Date	Number	Page
04.11	RVXX1101	1(7)

Engine Harness Ground Feedback

SAFETY RECALL INFORMATION:

Repair A

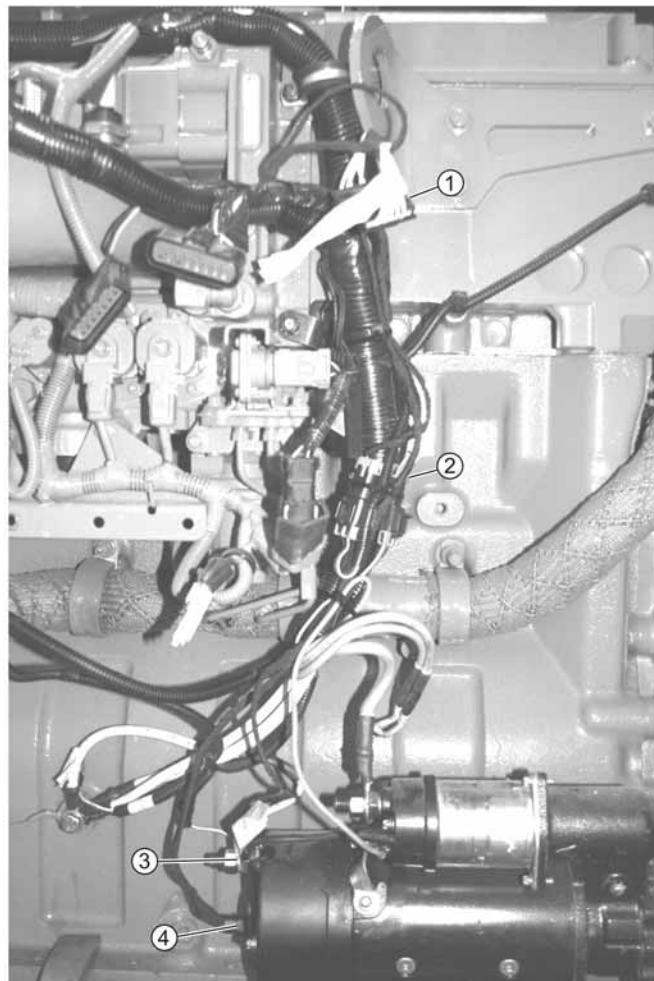
1. Secure the vehicle for service by parking it on a flat level surface, applying the parking brake, chocking the rear wheel, and placing the transmission in neutral.
2. Disconnect both the battery cables.
IMPORTANT NOTE! The POSITIVE BATTERY CABLE MUST BE DISCONNECTED FIRST! Removing the negative cable first will result in unintended engine cranking.
3. Locate and disconnect the front chassis engine interface (FCEN) connector on the left hand side of the engine. Insert the six way connectors of jumper harness PN 21669355 into the FCEN connectors. See photo position 1.

4. Locate the engine over crank protection (ENOCP) connector on the left hand side of the engine and remove the existing female connector fold back and tie. Insert the ENOCP female connector of the new jumper harness.
5. Locate the over crank protection (OCP) connector at the rear of the starter. Remove the existing male connector fold back and tie. Insert the OCP male connector of the new jumper harness on the rear of the starter.
6. Remove the nut securing the ground connections on the rear of the starter and install the ring terminal of the jumper harness. Torque ground stud nut to 30.5 ± 3.5 Nm (22.5 ± 2.6 ft-lb).
7. Secure harness with cable ties as needed.
8. Reconnect all previously removed cables to the battery terminals, then switch the main disconnect switch to the ON position.
9. Check starter operation

Repair B

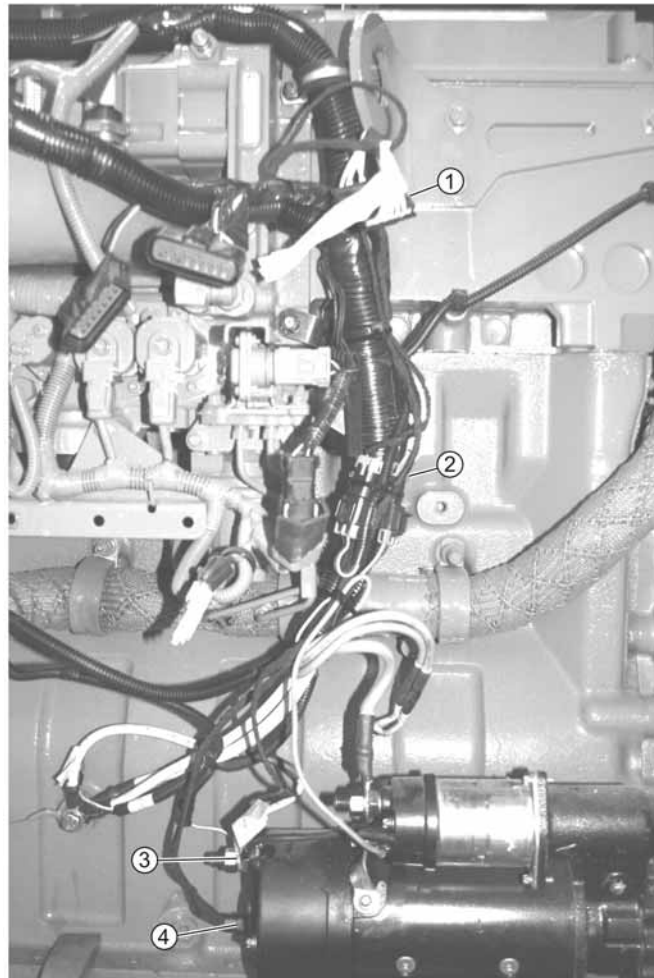
1. Secure the vehicle for service by parking it on a flat level surface, applying the parking brake, chocking the rear wheel, and placing the transmission in neutral.
2. Disconnect both the battery cables.
IMPORTANT NOTE! The POSITIVE BATTERY CABLE MUST BE DISCONNECTED FIRST! Removing the negative cable first will result in unintended engine cranking.
3. Locate and disconnect the front chassis engine interface (FCEN) connector on the left hand side of the engine. Insert the four way connectors of jumper harness PN 21676190 into the FCEN connectors. See photo position 1.

4. Locate the engine over crank protection (ENOCP) connector on the left hand side of the engine and remove the existing female connector fold back and tie. Insert the ENOCP female connector of the new jumper harness.
5. Locate the over crank protection (OCP) connector at the rear of the starter. Remove the existing male connector fold back and tie. Insert the OCP male connector of the new jumper harness on the rear of the starter.
6. Remove the nut securing the ground connections on the rear of the starter and install the ring terminal of the jumper harness. Torque ground stud nut to 30.5 ± 3.5 Nm (22.5 ± 2.6 ft-lb).
7. Secure harness with cable ties as needed.
8. Reconnect all previously removed cables to the battery terminals, then switch the main disconnect switch to the ON position.
9. Check starter operation

Repair C

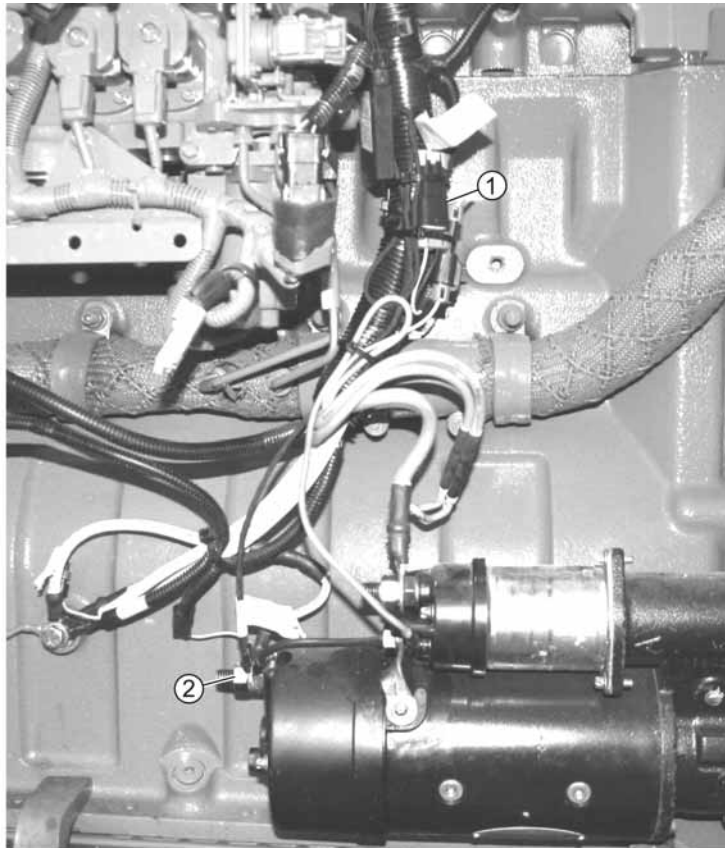
1. Secure the vehicle for service by parking it on a flat level surface, applying the parking brake, chocking the rear wheel, and placing the transmission in neutral.
2. Disconnect both the battery cables.
IMPORTANT NOTE! The POSITIVE BATTERY CABLE MUST BE DISCONNECTED FIRST! Removing the negative cable first will result in unintended engine cranking.
3. Locate the engine over crank protection (ENOC) connector on the left hand side of the engine and remove the plug from the connector and insert the ENOC connector of the new jumper harness PN 21676192. See photo position 1.

4. Remove the nut securing the ground connections on the rear of the starter and install the ring terminal of the jumper harness. Torque ground stud nut to 30.5 ±3.5 Nm (22.5 ±2.6 ft-lb).
